# PLANNING DIVISION

## GENERAL APPLICATION

Location Address: 3255 Hollywood Blvd, Suites 1 and 2

HOLLYWOOD HILLS PLAZA OUTPARCEL  
FINAL TAC SUBMITTAL

PAVING, GRADING & DRAINAGE PLAN

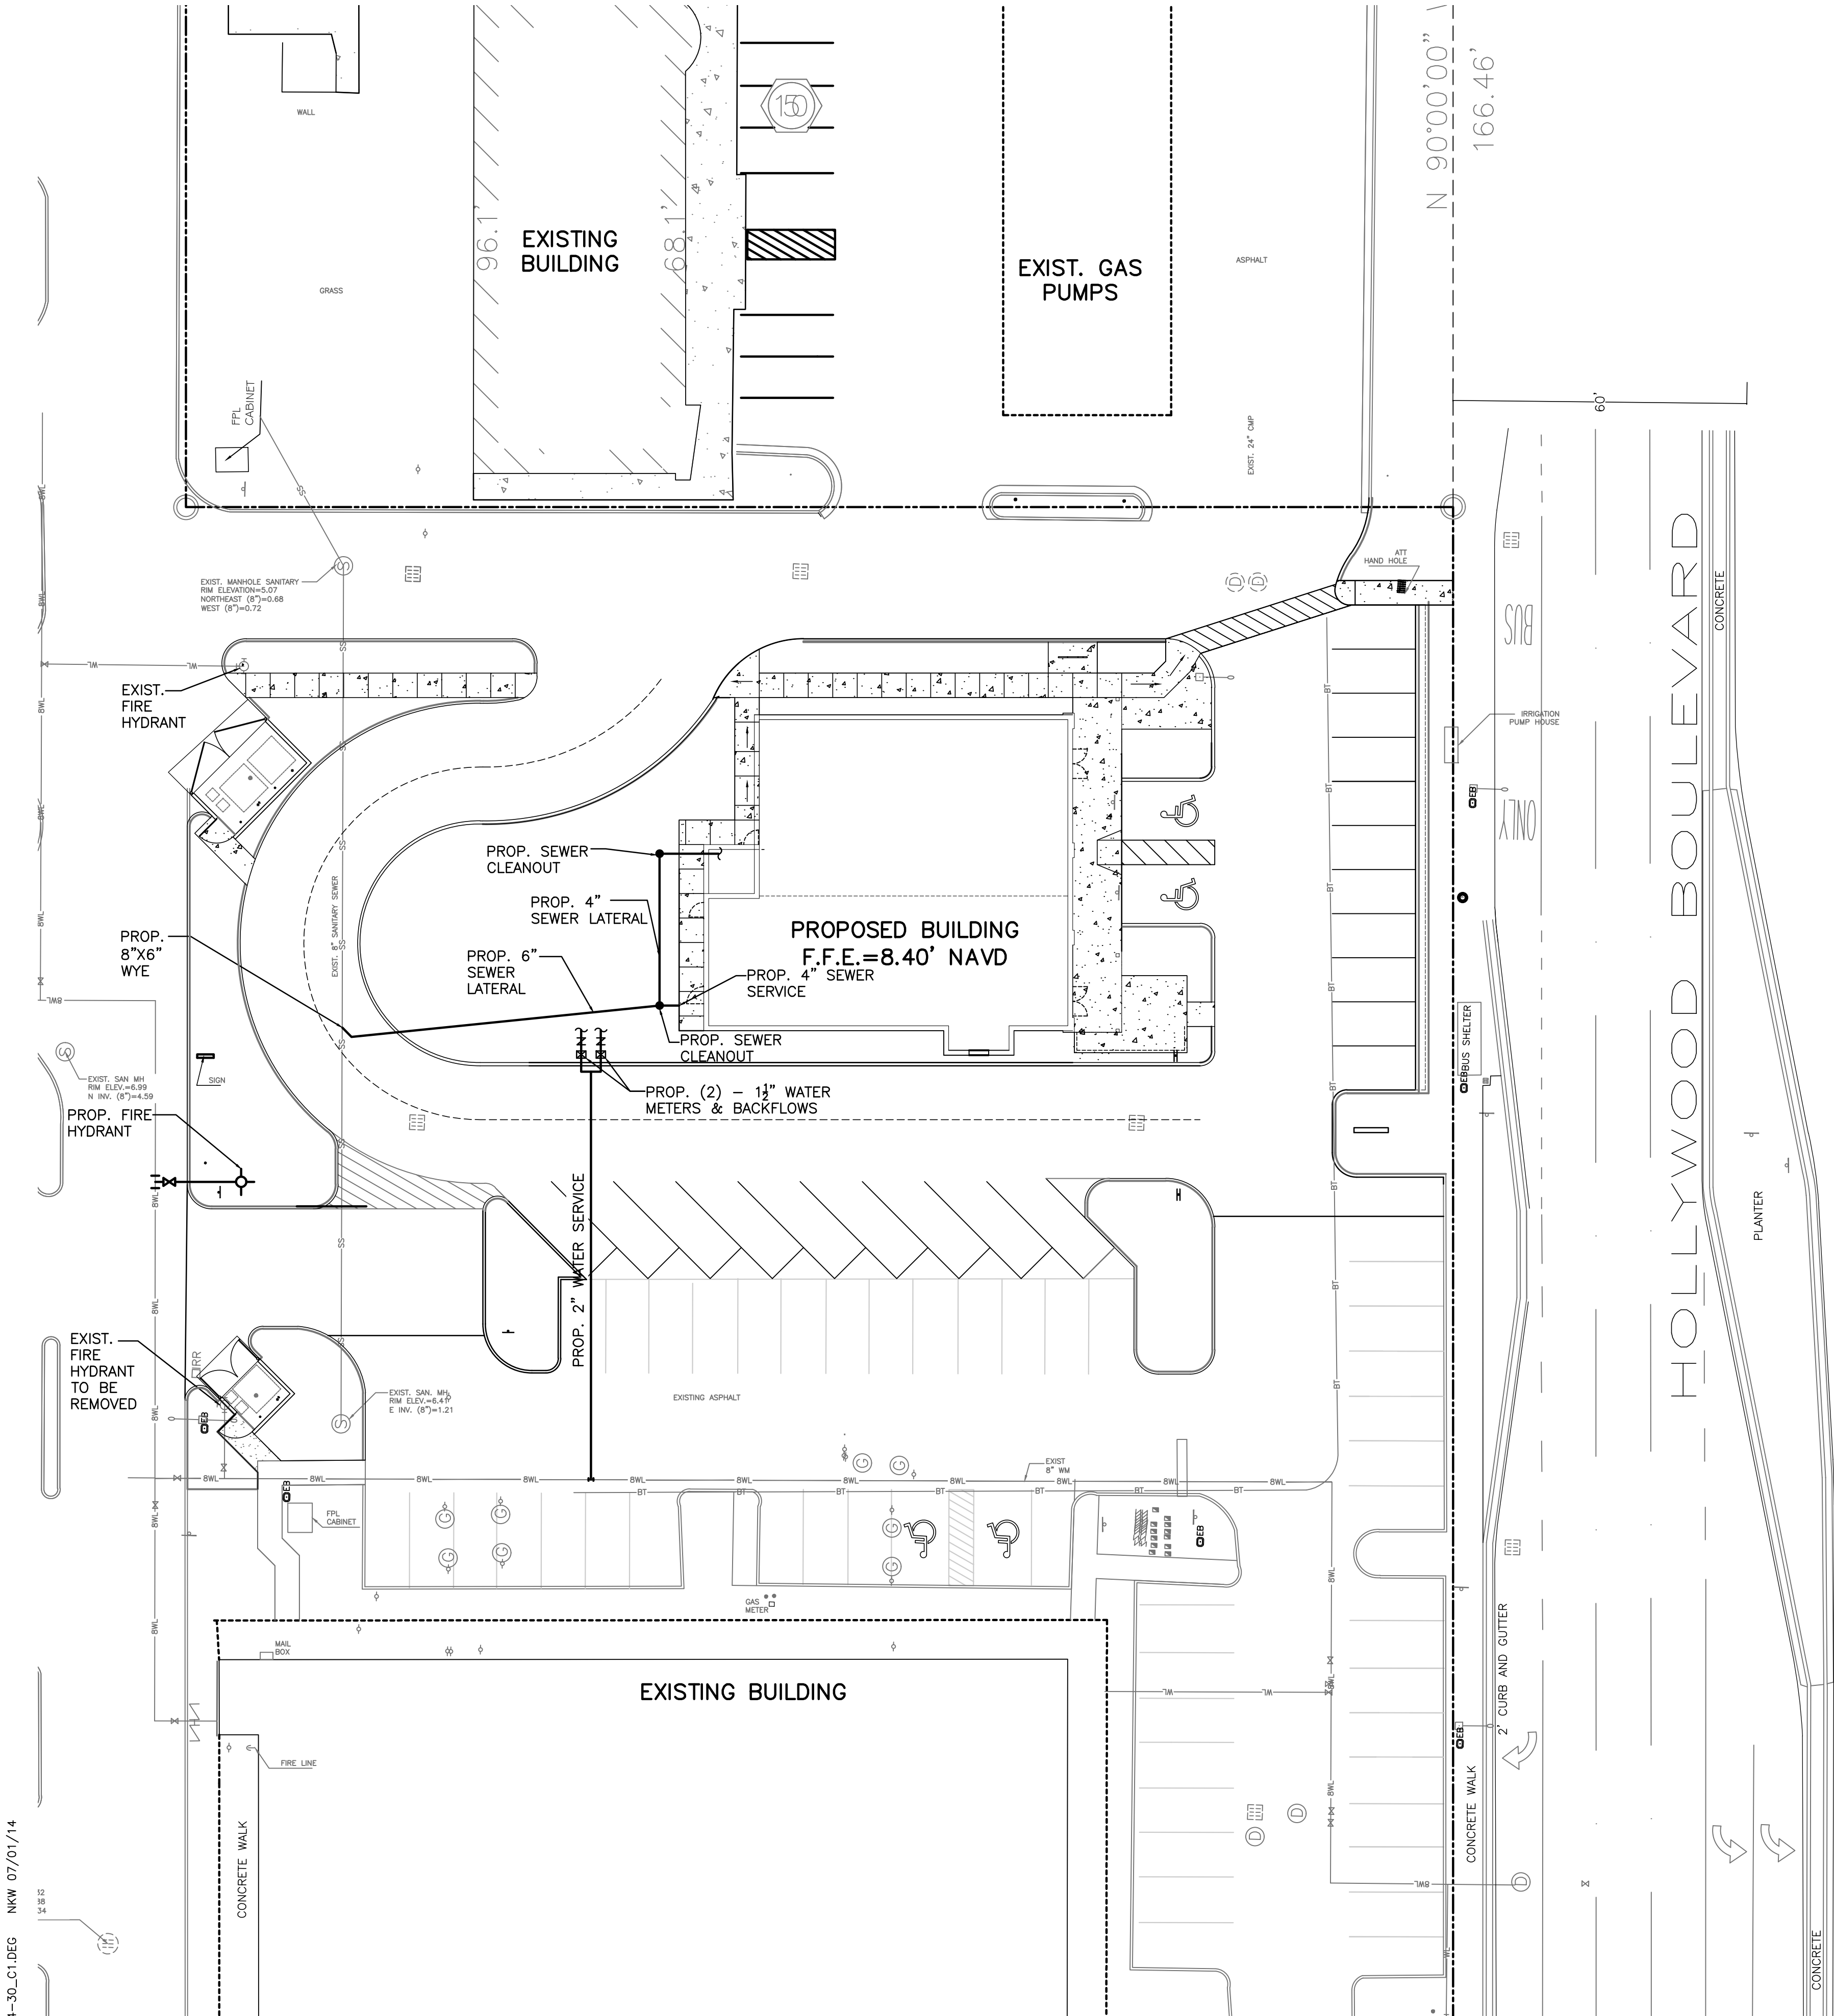
1. Comment: No Submit preliminary drainage calculations meeting Broward County and SFWMD requirements for pre/post development and soils report for review of length of exfiltration trench and ensure that stormwater will have sufficient storage.

- Response:** *Preliminary drainage calculations are provided showing the site is providing water quality as required by the existing SFWMD permit.*
2. Comment: Since this property resides within FEMA FIRM Zone X, no base flood elevation (BFE) is provided. Therefore, the Finished floor elevations (FFE) and bottom of equipment elevation must conform with section 154.50 of the City's Code of Ordinances. That is, lowest FFE and bottom of a/c and other equipment serving the building must be set at a minimum of 6-inches above the highest adjacent crown of road elevation. During building permit submittal, update survey to include adjacent crown of road elevations.

HOLLYWOOD HILLS OUTPARCEL  
HOLLYWOOD, FL

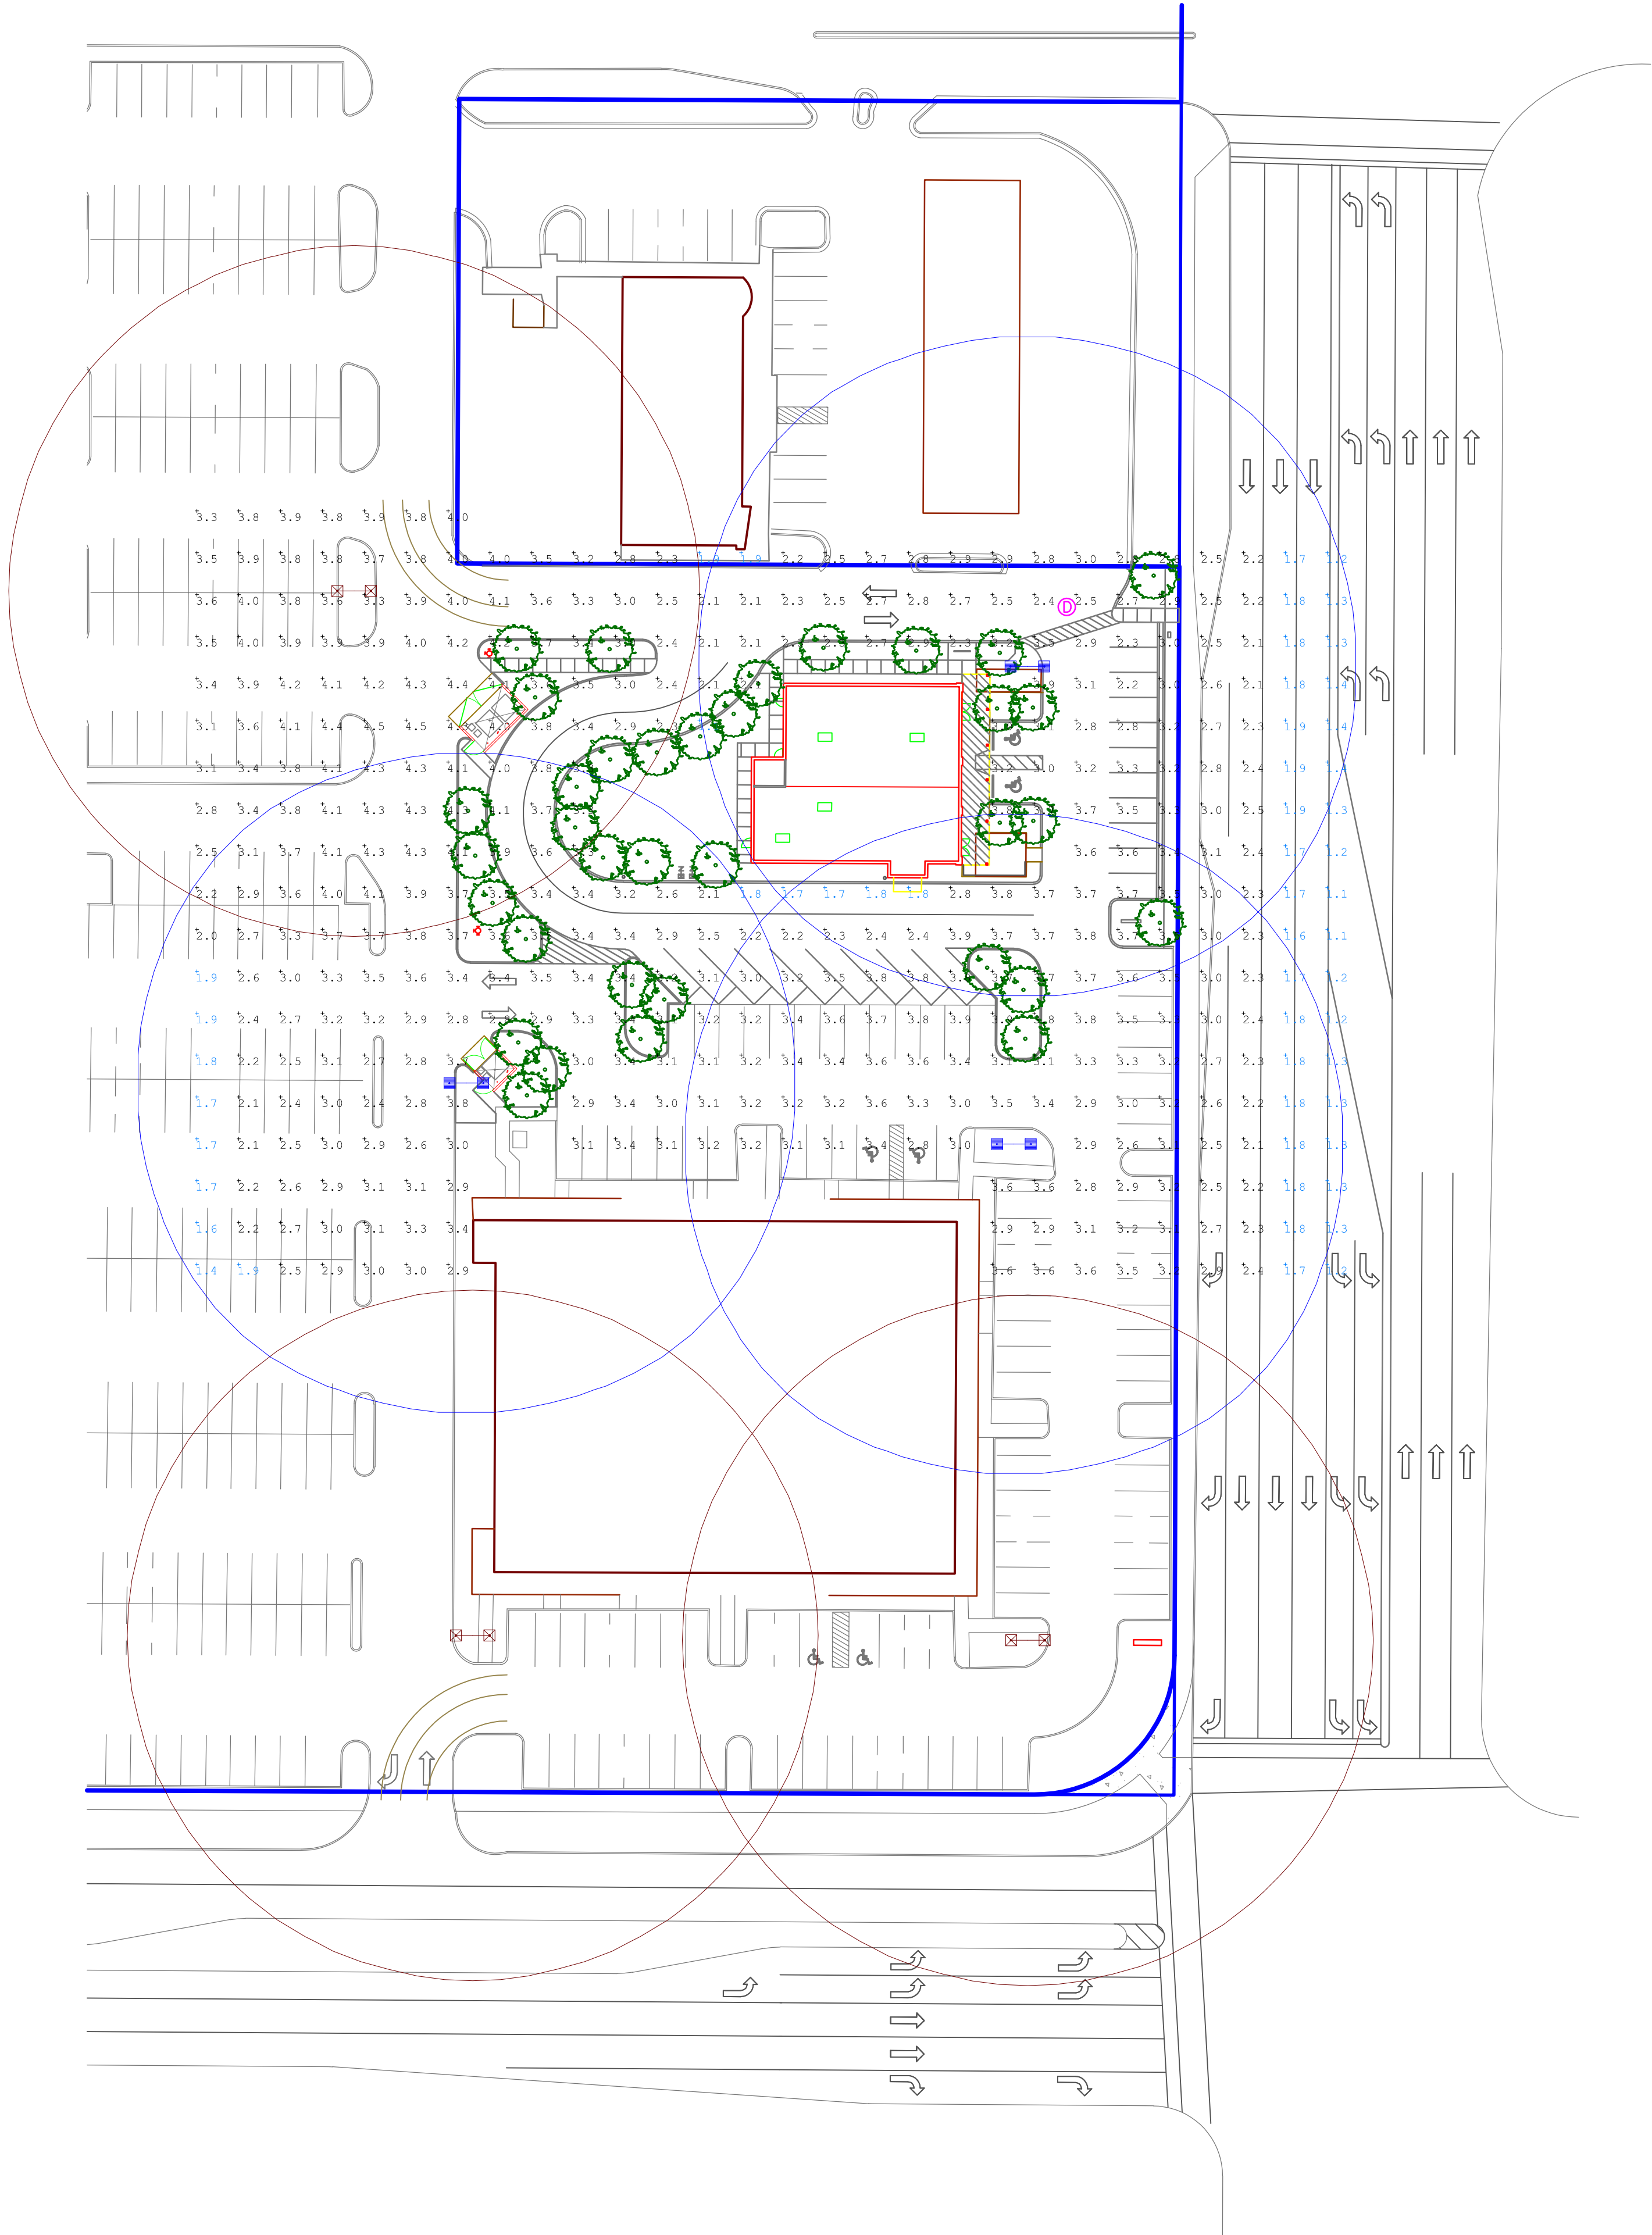
1. Comment: Parking lots, vehicle roadways, pedestrian walkways and building entryways should have “adequate” levels of illumination. The American Crime Prevention Institute recommends the following levels of external illumination:

**Response:**      *Please refer to attached Photometrics Plan.*
